November 26, 2002

“AP1000 Design Certification Review –
Response to Request for Additional Information”

AP1000 DESIGN CERTIFICATION REVIEW

Response to Request For Additional Information

Figure 3.8.3-7
IRWST Temperature Transient

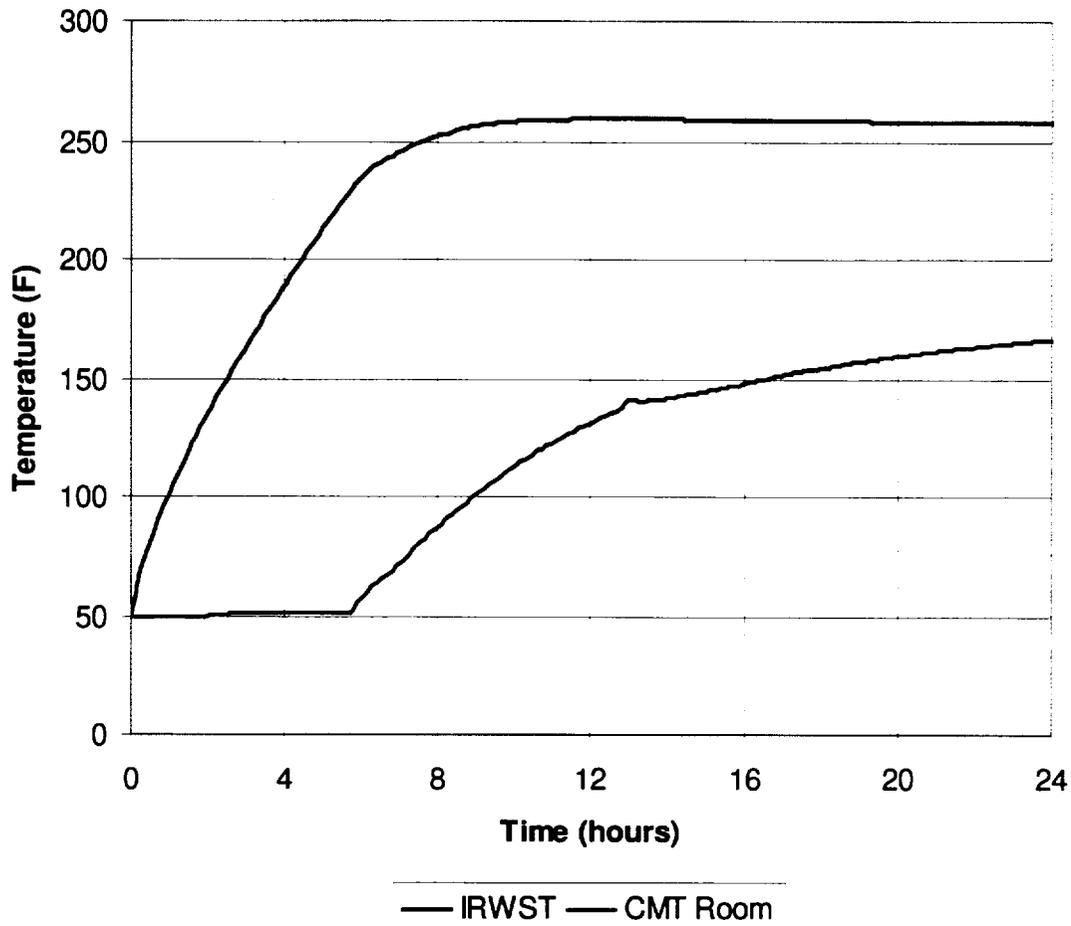
- A. The transient temperature was revised from 240°F reached in 5.5 hours (AP600) to 250°F reached in 3.5 hours (AP1000). Provide a discussion to explain the change and how this change was considered in the analysis and design of the AP1000 modules?
- B. The extreme transient starting temperature used for the structural design was revised from 50°F (AP600) to 70°F (AP1000). This would seem to be less extreme than the 50°F case in the AP600 design. Provide the basis for this change and explain how this change was considered in the analysis and design of the AP1000 modules?

The IRWST temperature transient is shown in the attached Figure 3.8.3-7, which will be added in the DCD. The IRWST begins steaming approximately 5 hours after the event is initiated, and reaches a maximum temperature of 259°F in approximately 11 hours. The containment atmosphere heats up once the IRWST steams. This transient will be used to determine the thermal loads on the IRWST walls. There are no changes in the analysis or design criteria for

Figure 155.1: Liquid Flows Upstream and Downstream of Bend

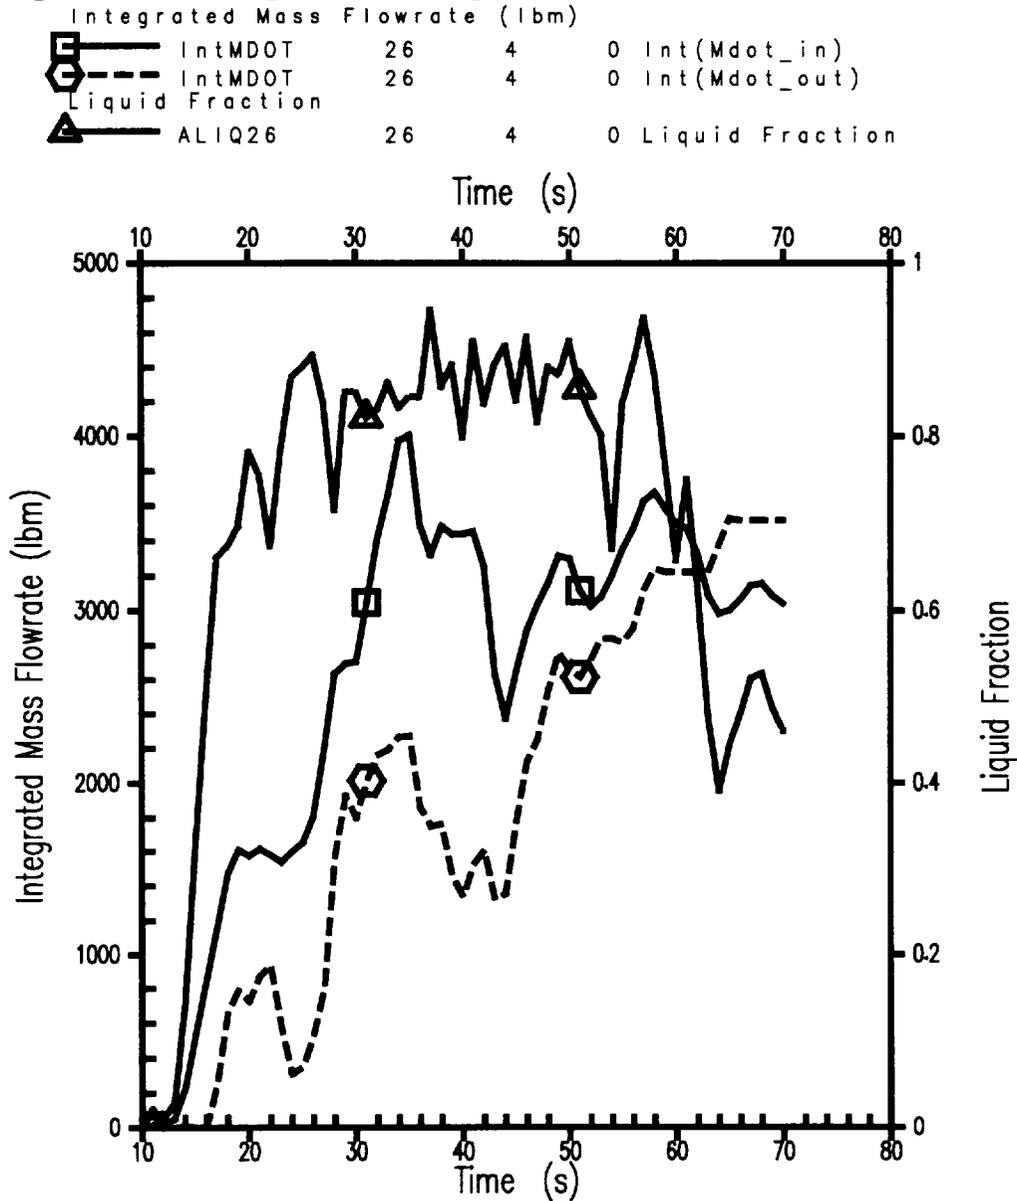
(a) The AP1000 WCOBRA/TRAC model shown in Figure 3.1 of WCAP-15833 indicates that Gaps 23 and 26 are located between ADS4 ports and the Steam Generator inlet plenum where an oscillating plug may be present. These gaps are connected to the hot leg bend channels, 23 and 26, where the downstream flow connection is vertical. It has been pointed out that the slugging transition by Taitel-Dukler flow regime map may be less limiting or inadequate for counter-current flows at the bend (see for example Reference [2]). In addition, as the reviewer commented, a particular flow configuration may exist at the ADS4 port and downstream of ADS4 where liquid may be trapped.

In a bend like channels 23 and 26, WCOBRA/TRAC tends to predict liquid buildup since the noding scheme allows liquid to build up by the lateral force balance (lateral momentum equations) at three vertical cells and the presence of interfacial drag vertically. Figure 155.1 shows the integrated liquid flow into (ADS4 side) and out of (Steam Generator side) Channel 26, and the liquid fraction in Channel 26 during the time period between opening of the first
